## The Fallacy of a Forecast

Consultants to the North Carolina State Ports Authority have provided a *Pro Forma Business Plan* for the proposed North Carolina International Terminal with a forecast of container movements. That is shown as the blue area in the chart below.

### Projected Annual Container Movements

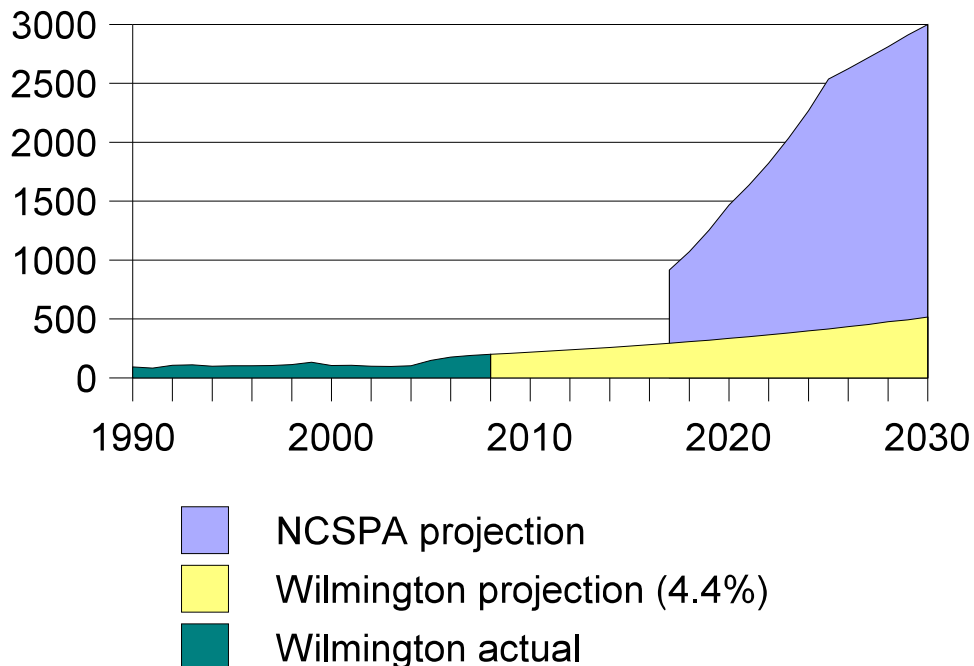
For the proposed new terminal, the consultants forecast container movements of nearly 1,000,000 TEU at the opening in 2017, growing rapidly to the capacity of 3,000,000 TEU in 2030.

How is that going to happen? That is fifteen times the current container traffic at Wilmington. The proposed new terminal is 20 miles downriver from Wilmington and would serve the same markets and be connected by the same roads and railroad.
